Modification of Development Consent

Section 4.55(1A) of the *Environmental Planning and Assessment Act 1979*

Modification Application: SSD 8606 MOD 2

Land: Hollinsworth Road, Blacktown
Lot 23 DP 262886
Lot 24 DP 262886

Figure 1: Site Layout

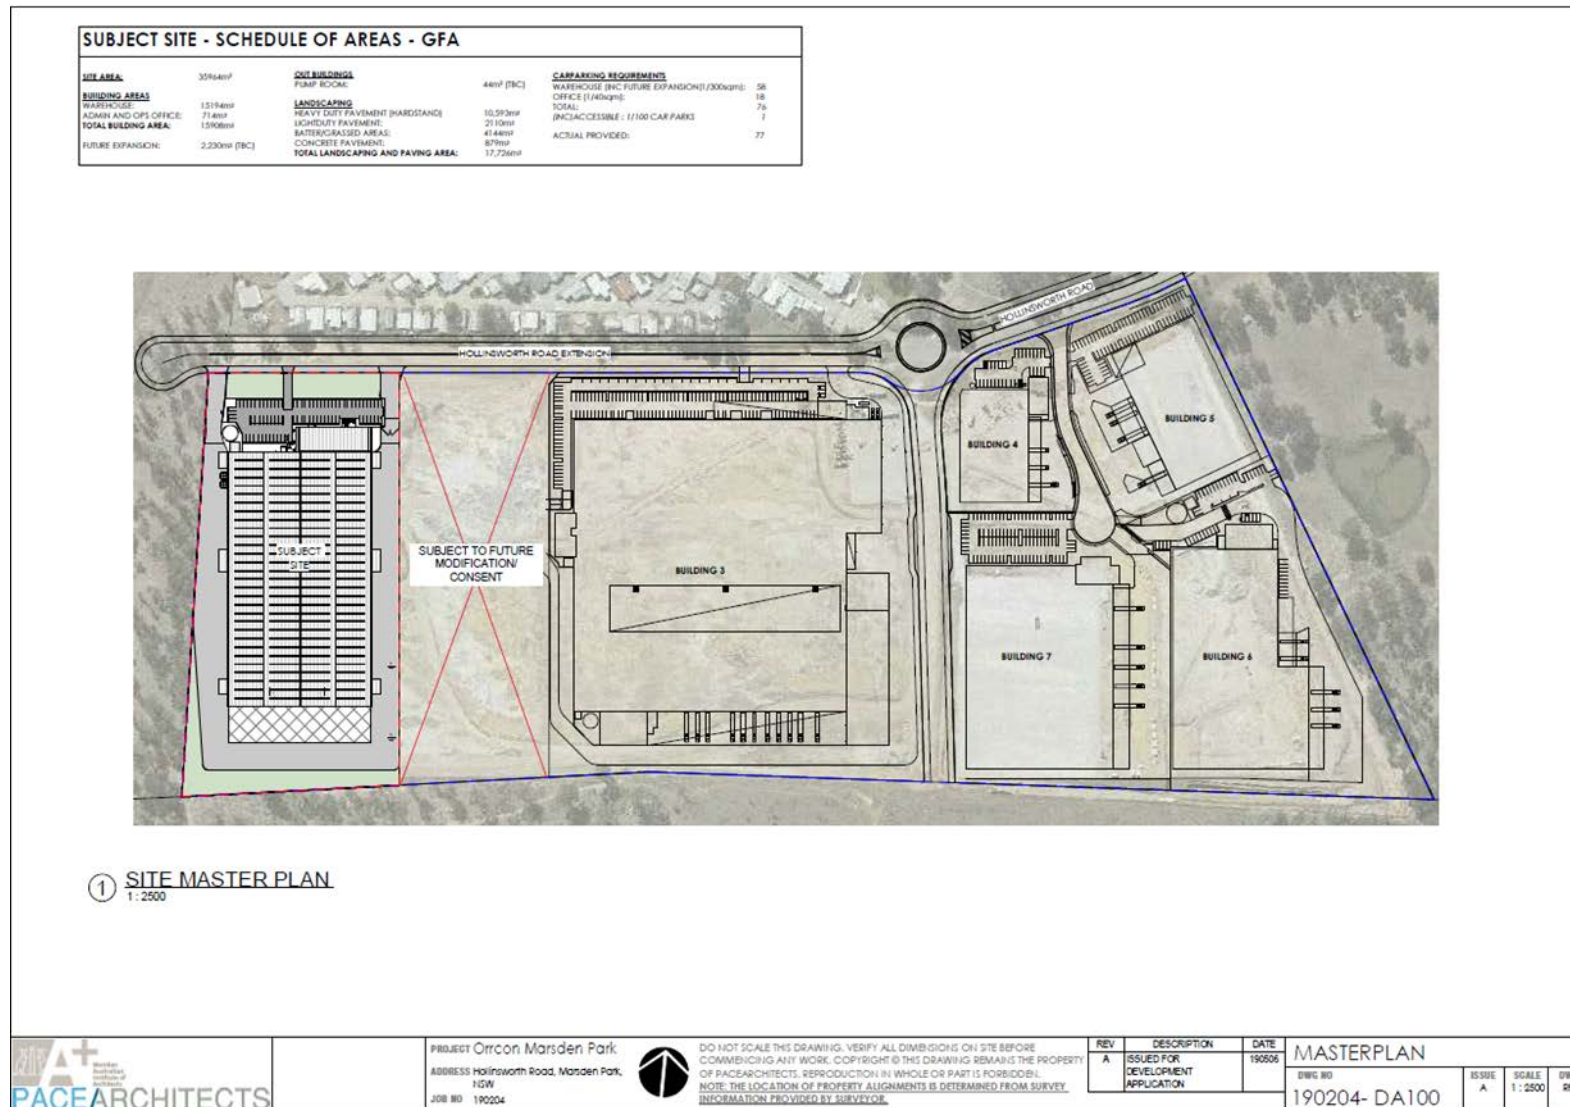
8. In Appendix A – Development Layout Plans, delete Figure 1: Site Layout and replace with 'Figure 1: Site Layout' as shown in Appendix A of this modifying instrument.
9. In Appendix A – Development Layout Plans, delete Figure 2: Staging Plan and replaced with 'Figure 2: Staging Plan' as shown in Appendix A of this modifying instrument.
